ELIZABETH ST.
87-5-26
PEAKS ISLAND

(A) APARTMENT HOUSE ZONE
APPLICATION FOR PERMIT

Subject: Building permit for alterations in the single
family dwelling house owned by Marion Stephenson on
Elizabeth Street, Peaks Island--Assessors Lot No.
97-2-25

Subject: Building permit for alterations
in the dwelling house of Marion L. Stephen-
son on Elizabeth Street, Peaks Island

Proposed Addition
For
MARIAN L. STEPHENSON
ELIZABETH ST.
PEAKS, I.S.

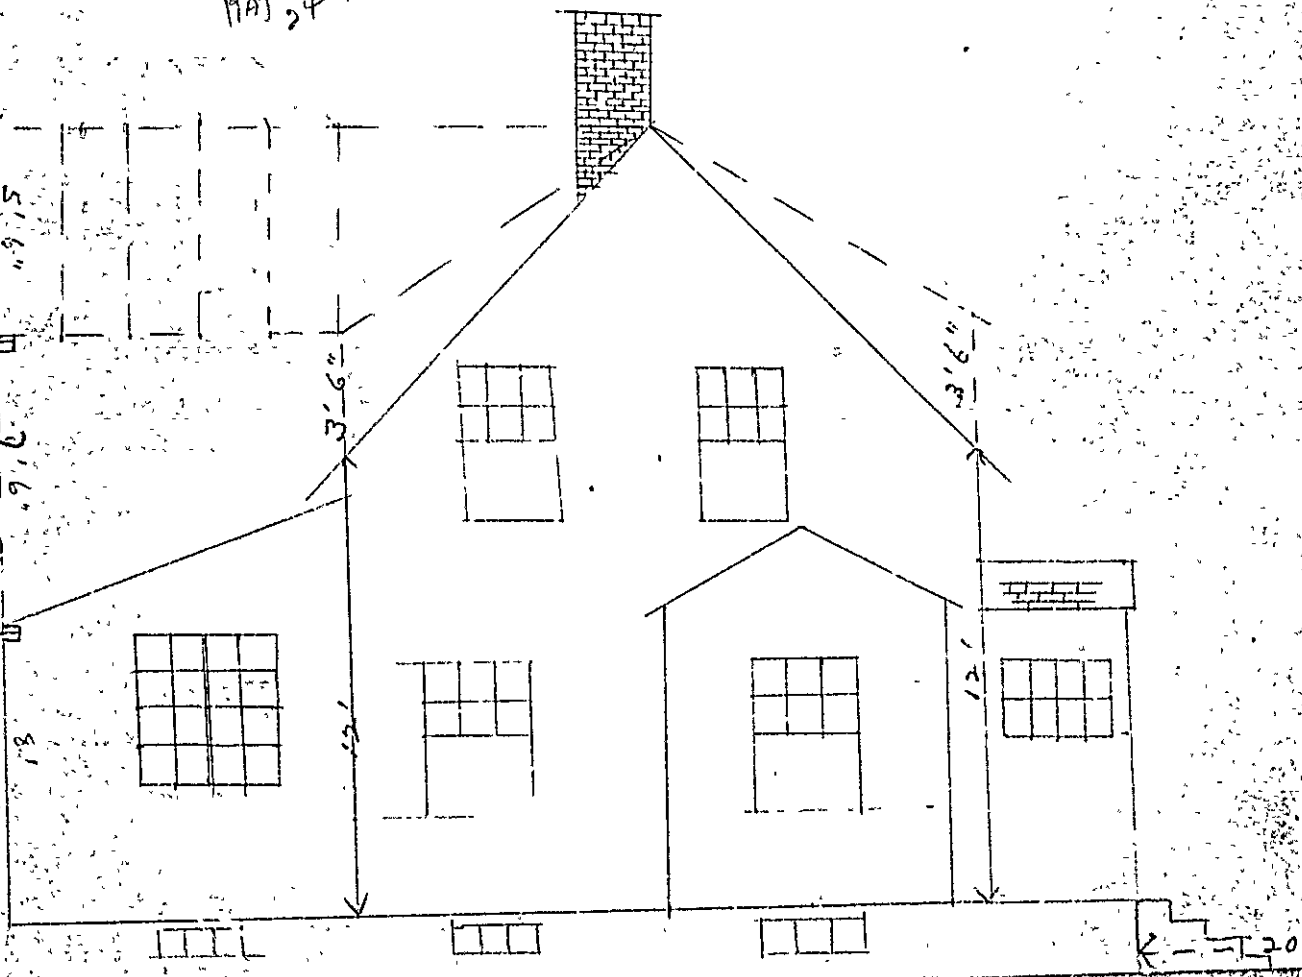
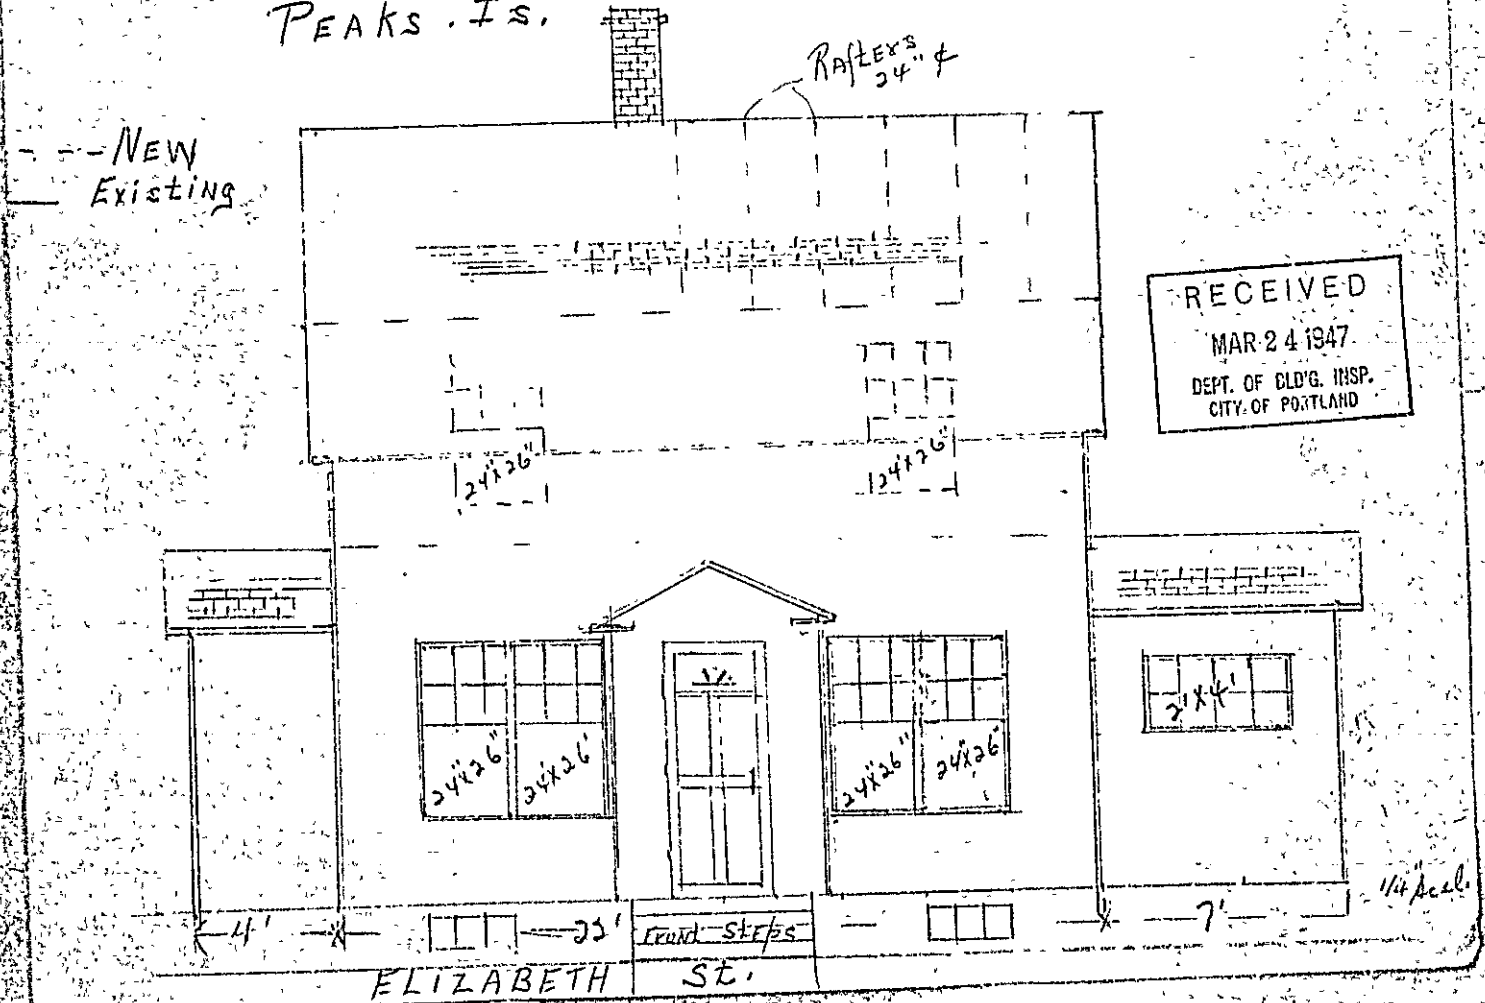
1. While I appreciate the large amount of comprehensive information shown on the plans, it is not possible for us to tell precisely how much of the work is existing and how much is proposed new or to be changed. Obviously, failure to call your attention to any deficiencies which we do not know about cannot relieve all concerned from compliance with Building Code requirements. The plans being original sketches, I cannot be sure whether you have a precise copy of them or not. Misunderstandings could arise if you do not have an exact copy. It appears to me that the second floor plan is in error in that it shows the rear part of the building extending clear to the west wall of the main house while the first floor and foundation plan show that the rear addition does not extend to this west wall by four feet.

2. Where the application calls for raising the roof of the building, including the present second story addition, it is understood that the entire second story and roof of one story portion is to be removed, down to girt or plate (there is objection to doing this in sections) and the new second story and roof built in the usual manner under the Building Code with 2x4 studs set vertically, no more than 16 inches from center to center and running from girt to under side of new plate. The application calls for 4x4 corner posts to be supplied from the present girt to the new doubled 2x4 plate. Normally a 4x6 corner post would be required on this 2-story building, but there would be little use in using 4x6 corner posts in second story if those below were only 4x4. If first story corner posts are 4x6, then 4x6 corner posts should be used in the second story. In any case, care must be exercised to splice out or in equivalent fashion stiffen the work at this point to, as far as possible, to satisfy the spirit of the ordinance which, on such a new building would require the corner post to run one length from sill to under side of plate with 18-inch lap splices allowed. Judging from the elevations, there is considerable doubt as to at what level the existing girt of the main house is located, and it may turn out that there is ledger board construction instead of a girt at the present second floor level. I cannot approve a proposition of clearing off the present roof of main building down to the present roof plate and then building up from there to the new plate unless some scheme is devised of providing ties across the building practically equivalent to normal floor joists. If there is any question about all of this, you should refrain from starting the work and give us more detailed information.

3. I have not discovered any information as to the framing of the new second story ceiling or attic floor if there is to be a floor. I take it that the framing shown on second floor plan is framing of the second floor. Inasmuch as more headroom is now to be provided on second floor, the loads will naturally be heavier. The second floor joists in front run parallel to the street--22 feet from side to side of the house, and it is not apparent what supports the joists of the partition between the two front bedrooms down through the first story. This and a number of other situations are not clear and will have to be cleared up in conjunction with the inspector in the field.

4. The 6x6 hard pine indicated as intended on a 9-foot span in the new opening between rear one-story portion and the 1½-story section does not work out strong enough. From the plans since this beam would support part of the second floor of addition, interior bearing partition in second story, about half of the roof load, and part of the tie or ceiling load over second story, I should say that you would have to go to either 4x10 or 6x8.

5. It is not clear which columns and piers are existing in the cellar and which are proposed, but it appears certain that the 6x6 girders shown under first floor of main house are not strong enough on the span shown. No doubt you are aware that any pipe columns to be supplied must be no less than four inches in outside diameter if they are of ordinary pipe, new or second-hand. A genuine specially manufactured pipe column—"Lally" or other make can be less than four inches in outside diameter if the design of it works out that way. The 6x6 girder shown on the first floor plan has no supports indicated under it unless there is a masonry wall between ell cellar and main cellar, and even so its strength would be doubtful. This 6x6 is shown running clear through the fireplace chimney.

6. I am not sure whether the fireplace and chimney are existing or are to be built, if either or both are to be built, care must be exercised of course about observing requirements of the Building Code for both fireplace and chimney, and supports of girders etc. independent of them.
